CHANGE ORDER

PROJECT: Williamson County Justice Center Renovations
405 Martin Luther King Drive
Georgetown, Texas 78626

CHANGE ORDER NO: 001

DATE: June 25, 2021

ENLARGED
NEW CONSTRUCTION
PLANS - LIGHTING

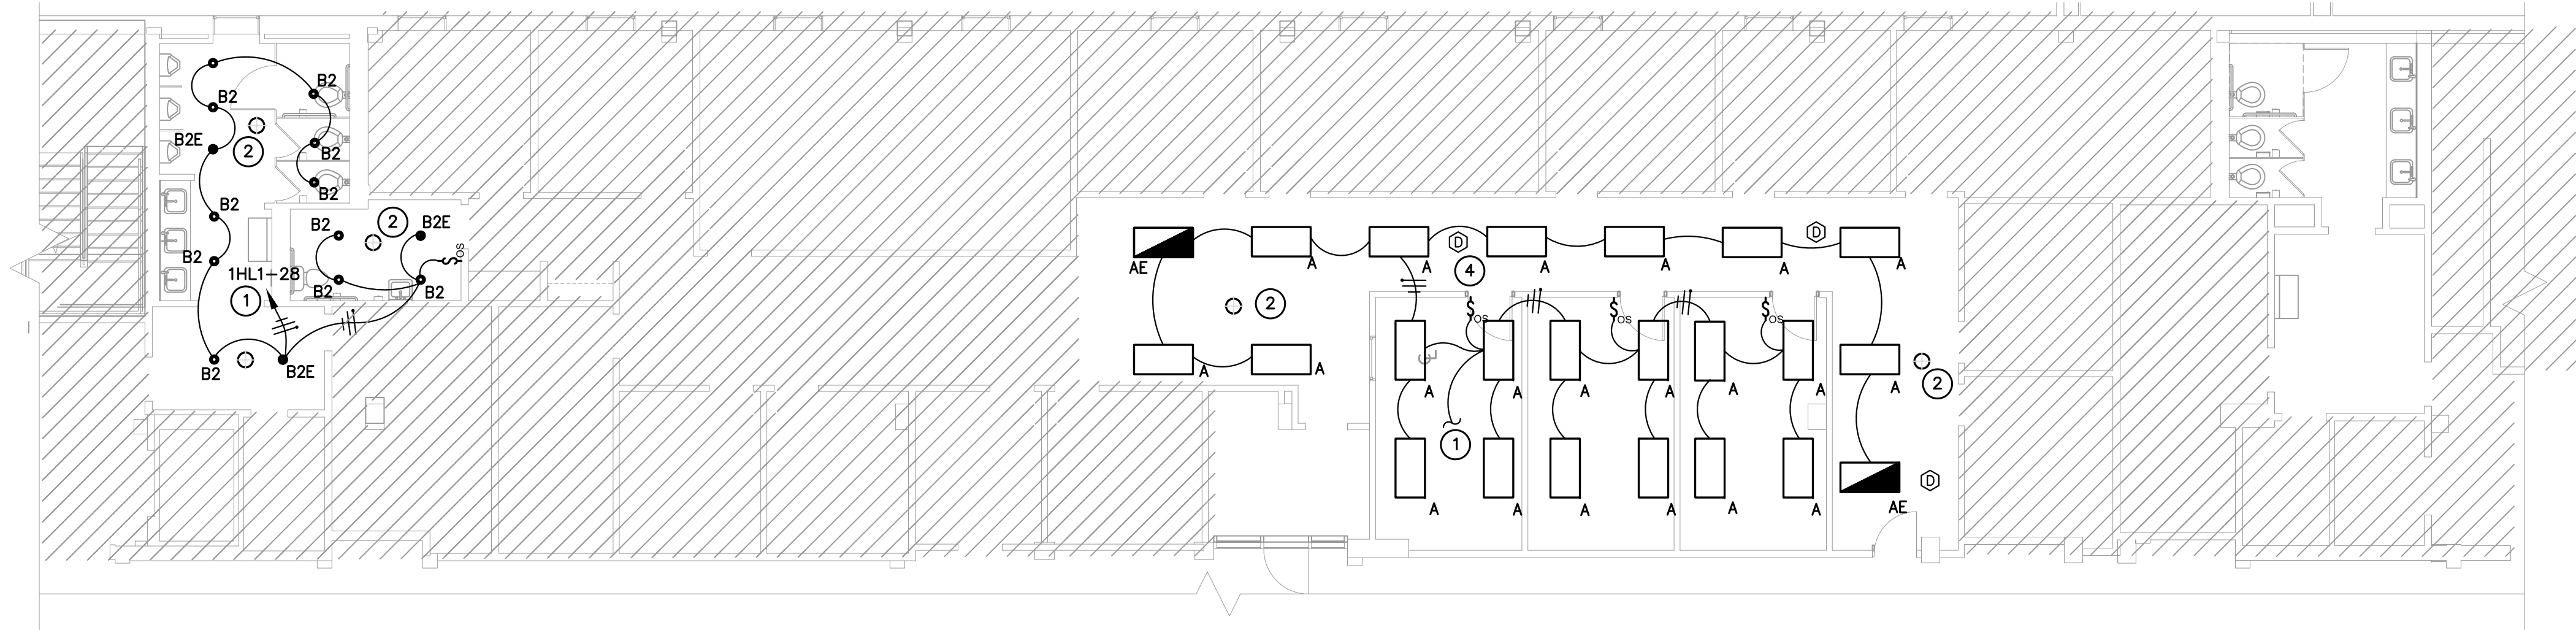
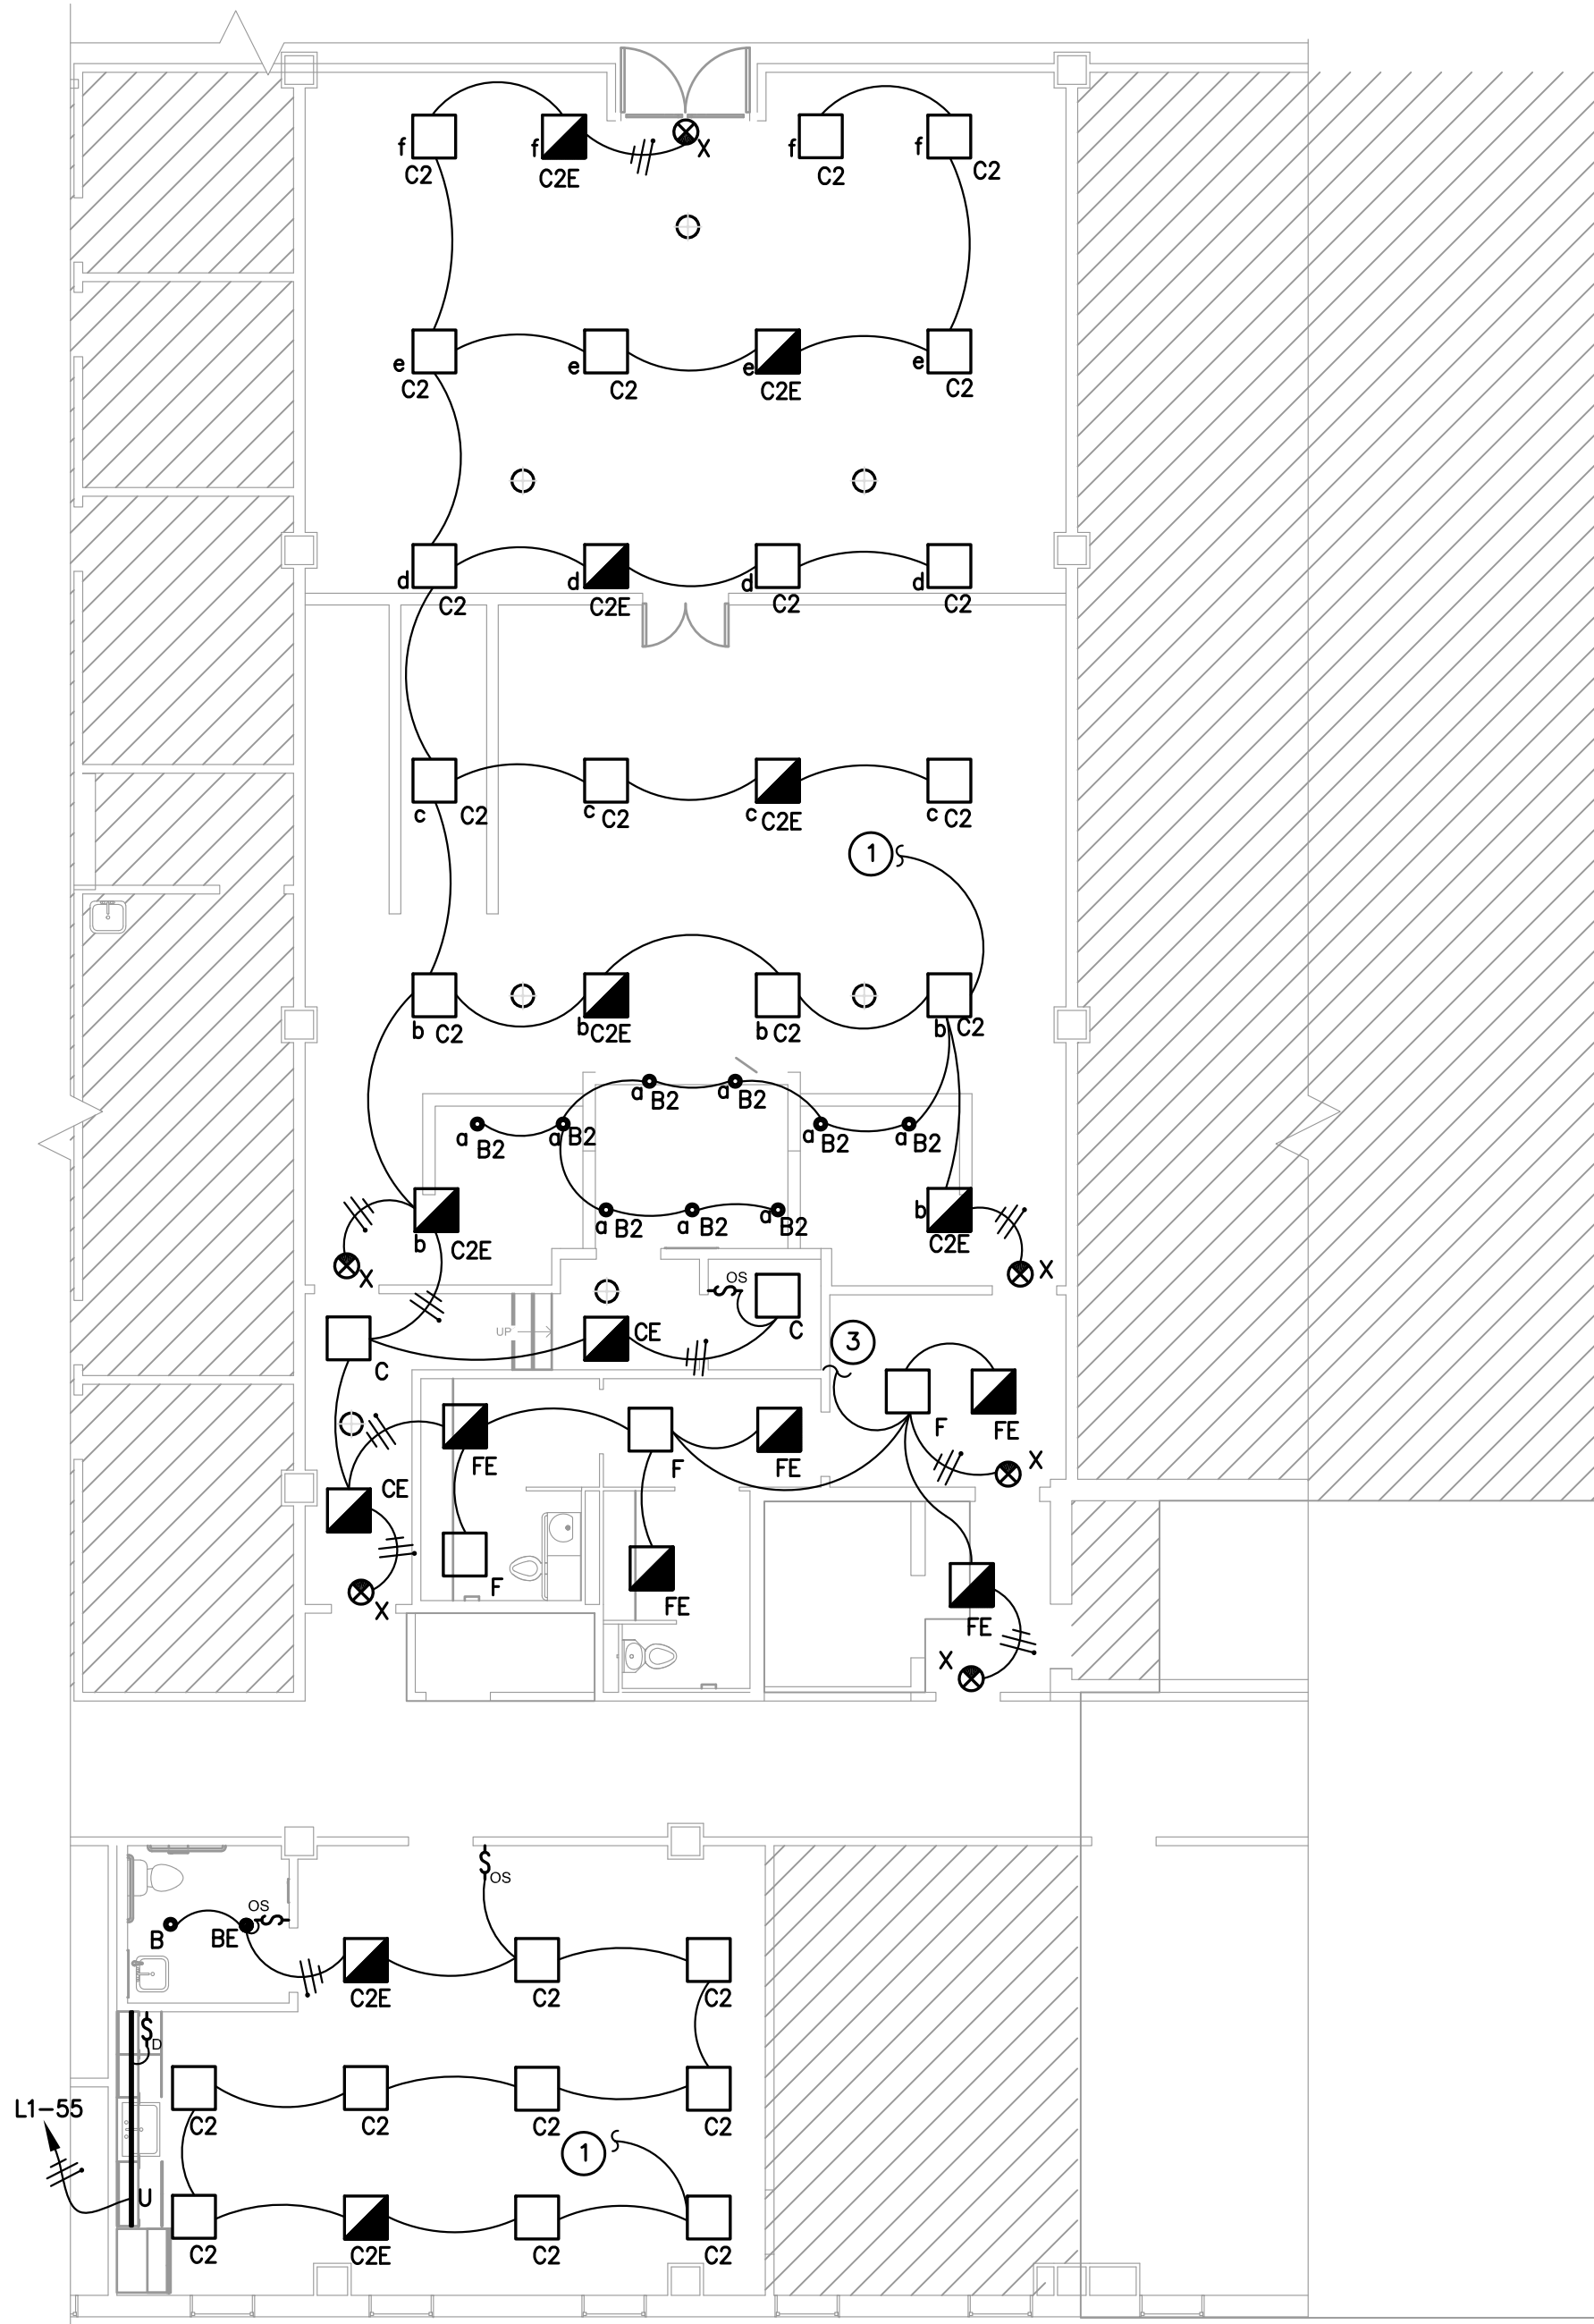
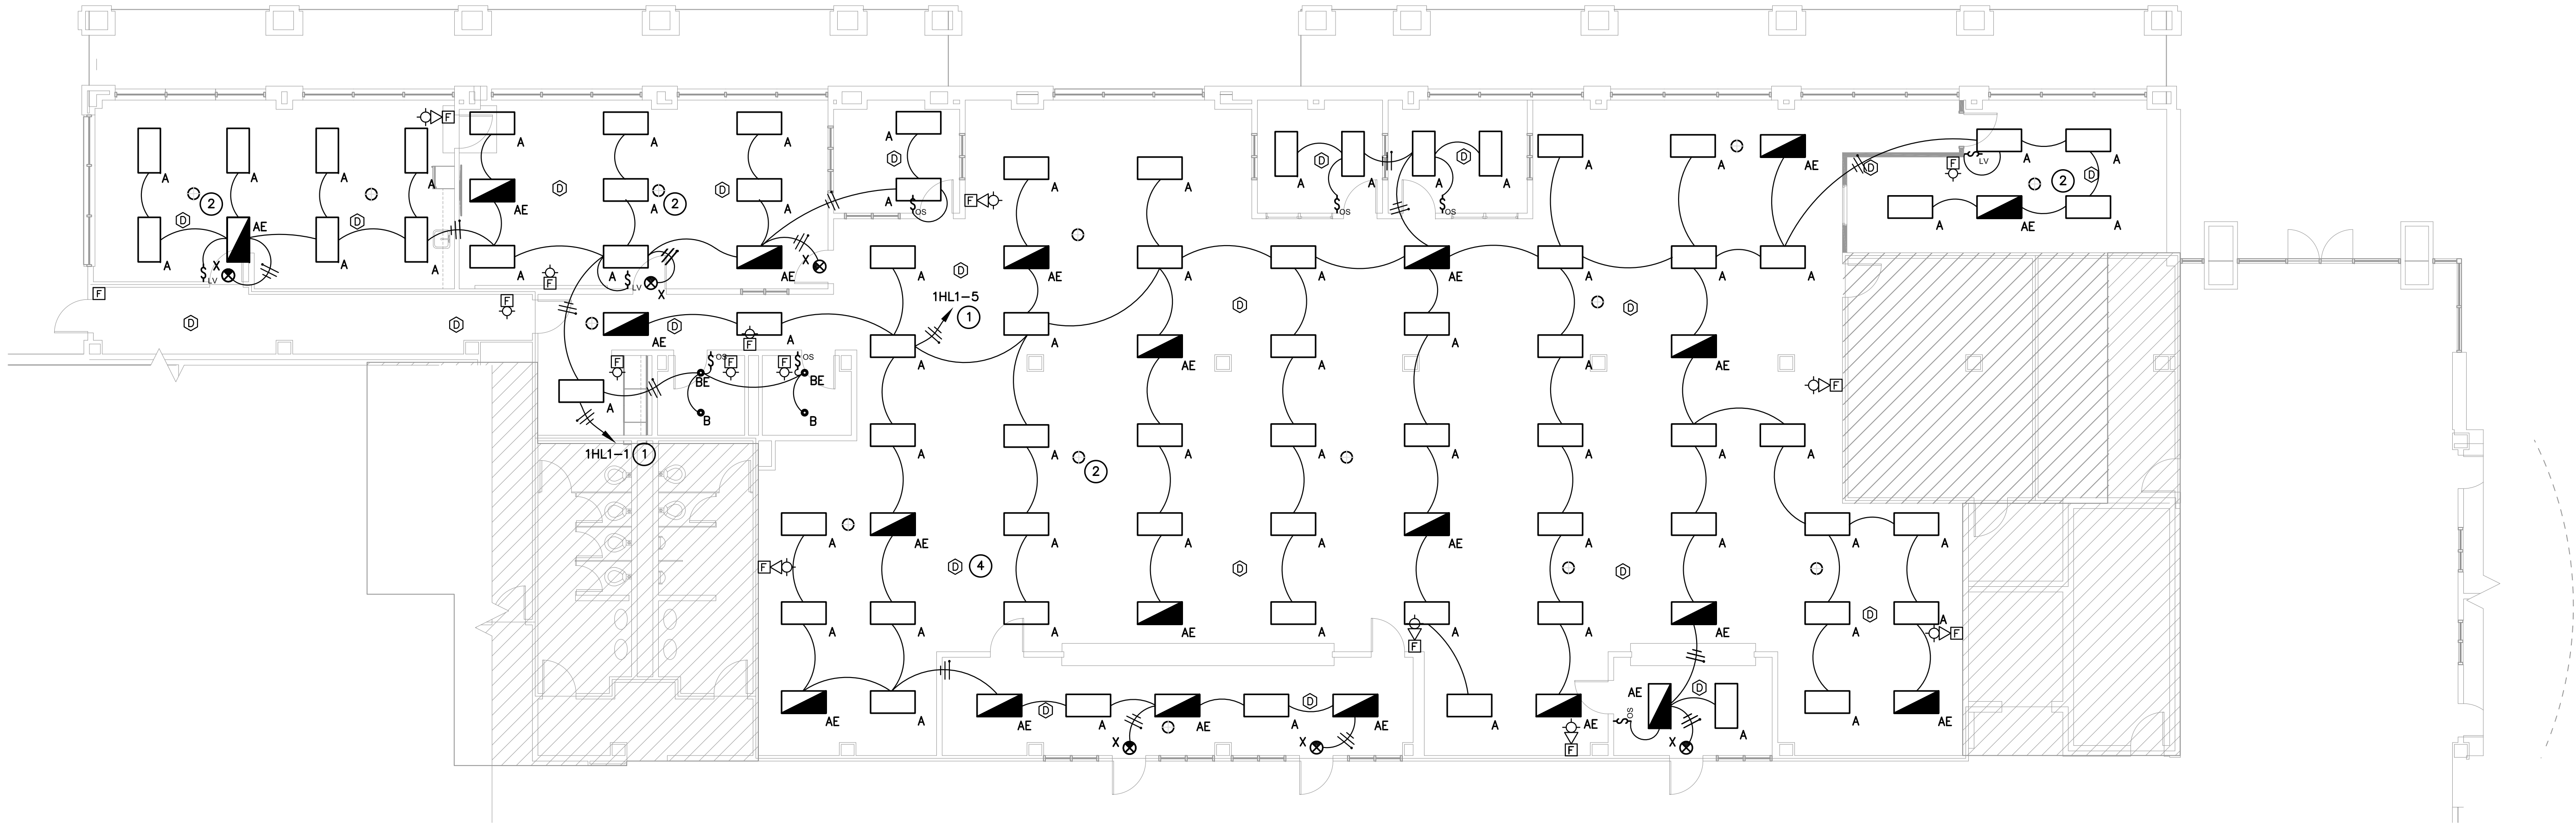
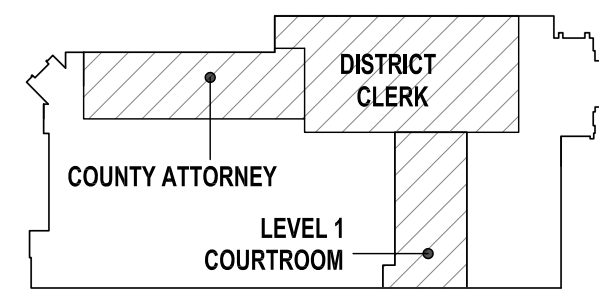
ASI 1

Provide dedicated circuit to panel L1 for refrigerator
receptacle

Provide dedicated circuit from emergency panel LE1 on the roof to new court room doors

LOWER CASE LETTERS ADDED TO SHOW LIGHTING CONTROL ZONES.
